SITE INSTRUCTION

SI A13

PROJECT : Forestside
PROJECT # : 1331.15
DATE : Dec. 3, 2021

Title: Revisions to plans as itemized.

WEST ELEVATION 4
1:100 A402

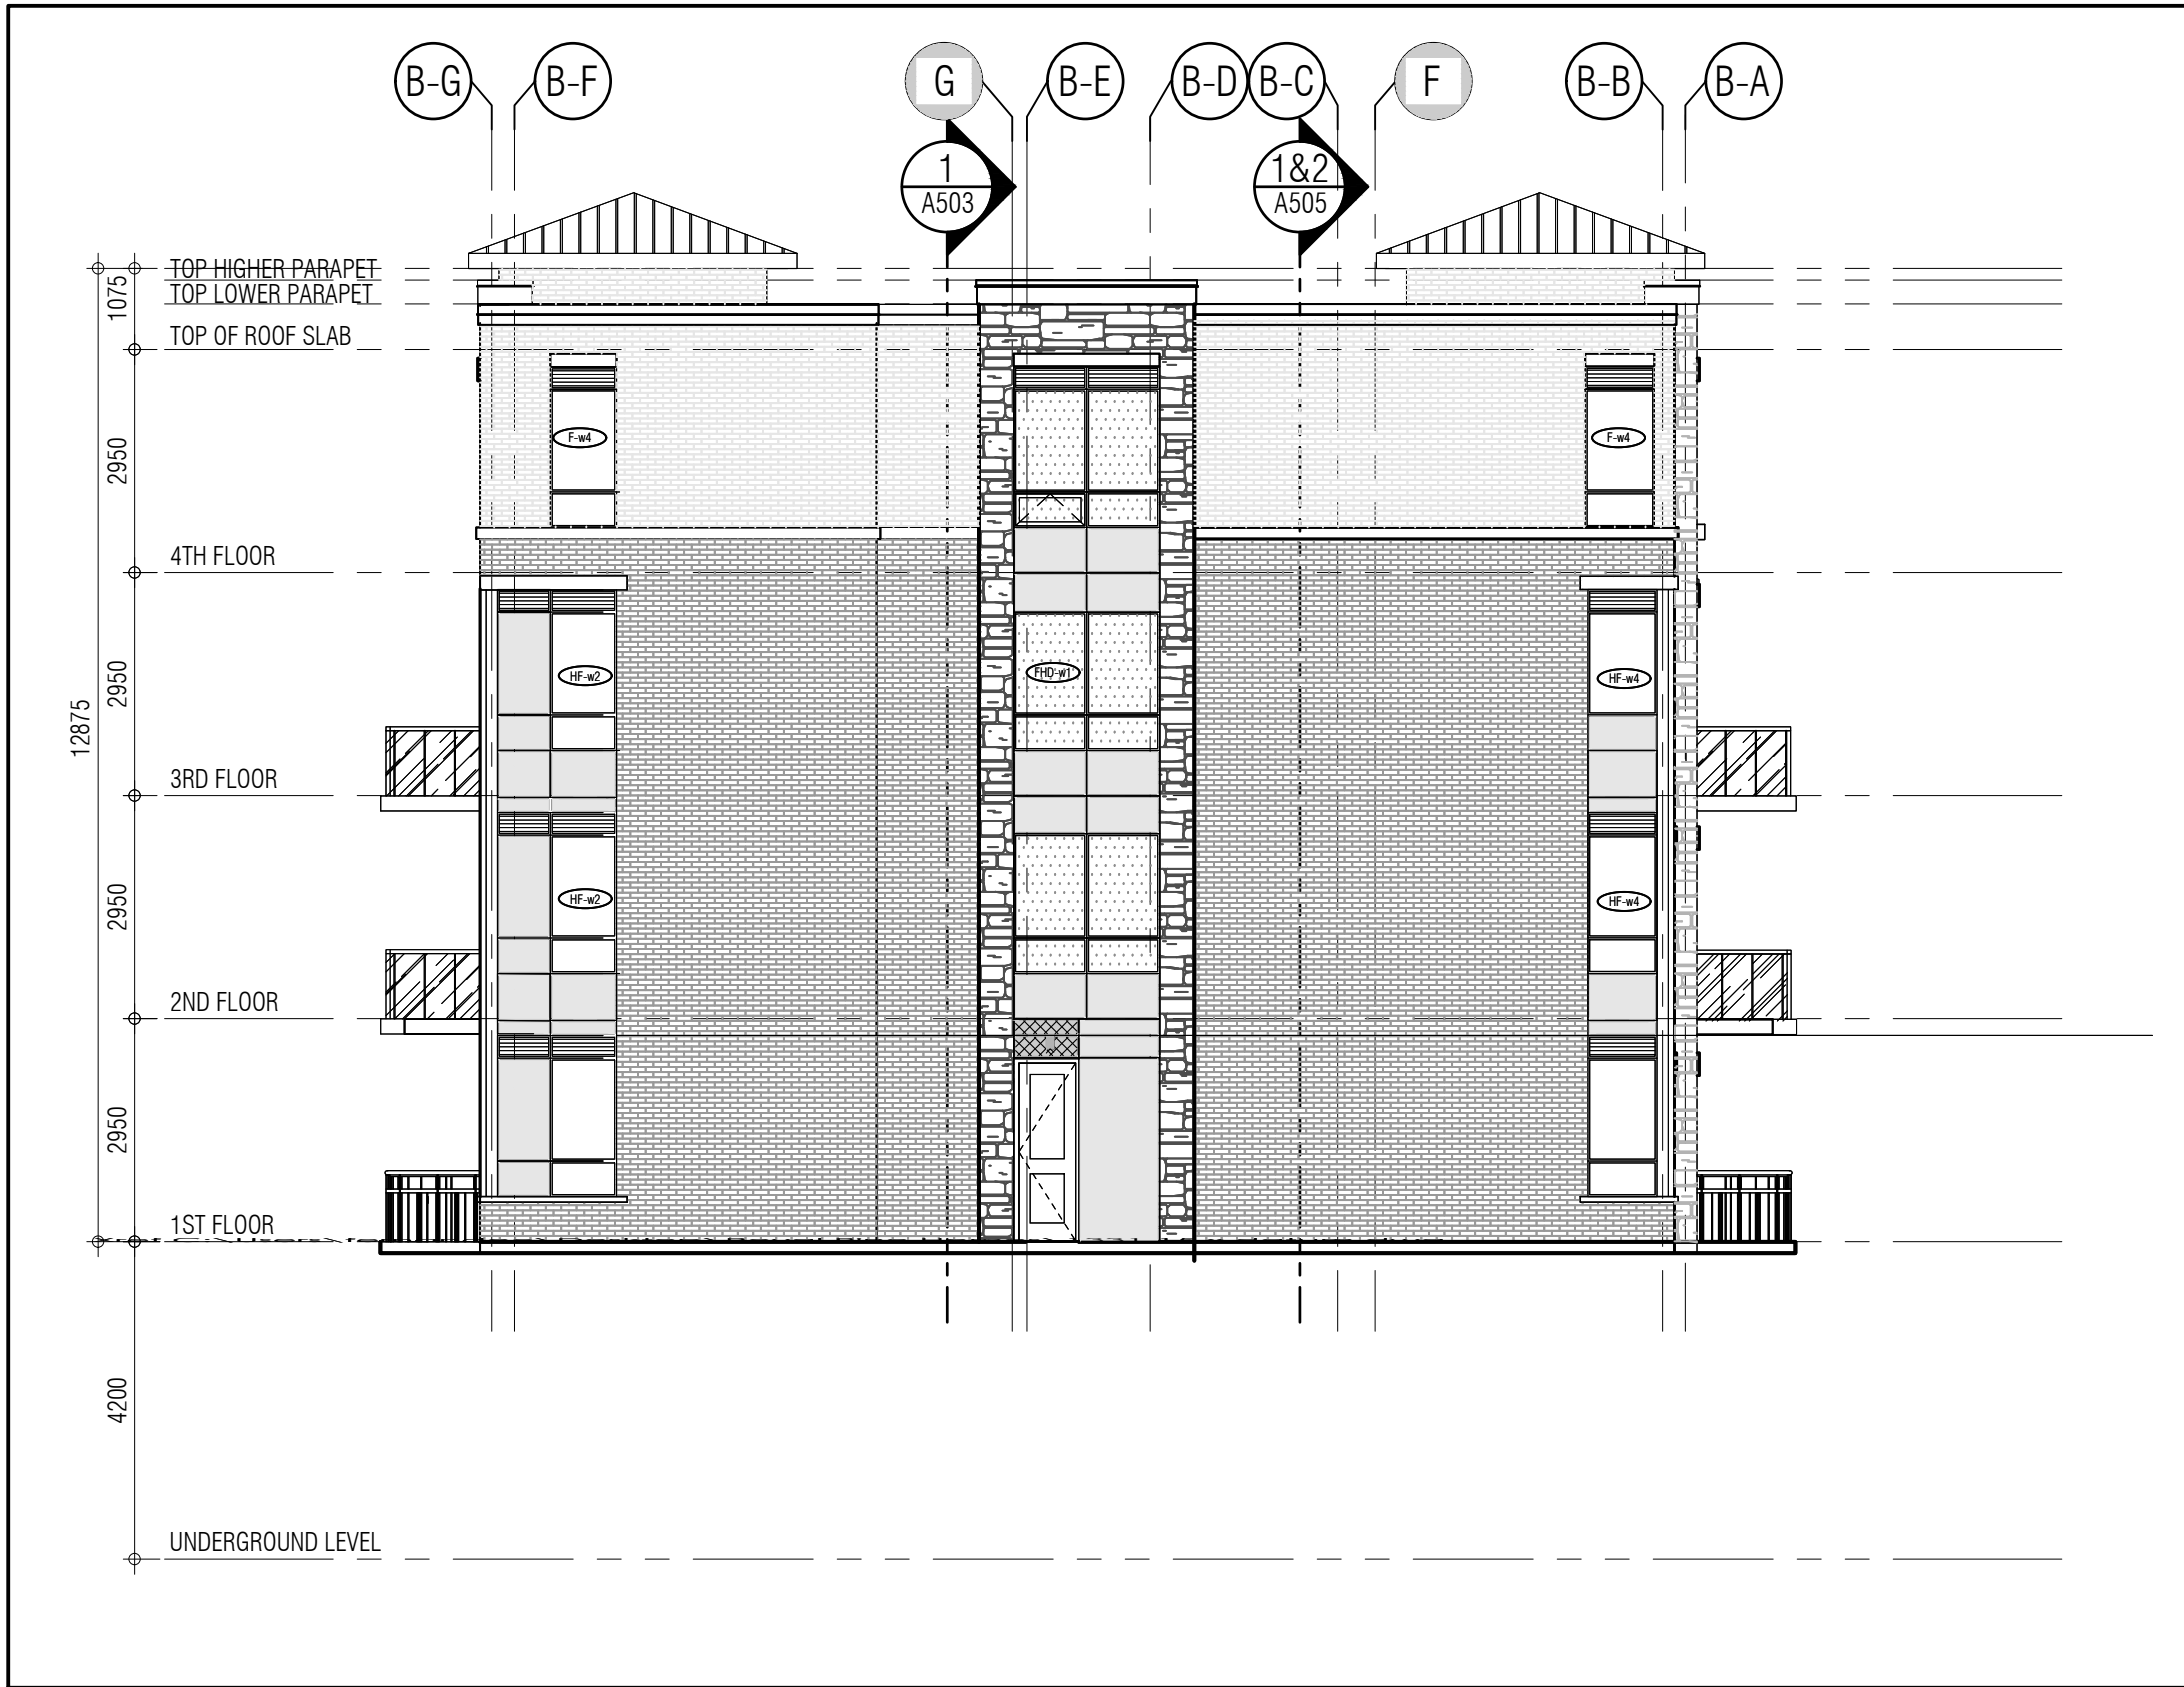
Reference:		Changes:
CS304a1, a2 CS304b1, b2 CS304c1, c2 CS304d1, d2	4th Floor Slab Edge	Revise spot elevation of higher roof parapet at front lobby wall.
A401, A401a1 A402, A402b2 A403, A403c1 A404, A404d1	Elevation Building A Elevation Building B Elevation Building C Elevation Building D	Revise height of window wall, louvre location heights to match front lobby wall parapet height.
A503	Sections	Revise dimensions, window wall, and louver location heights of front lobby wall parapet match window shop drawings.
A900	Window Schedule	Revise dimensions, window wall, and louver location heights of front lobby wall parapet match window shop drawings.

Reason: Revisions to plans of parapet heights and as per window shop drawing coordination at front lobby wall.
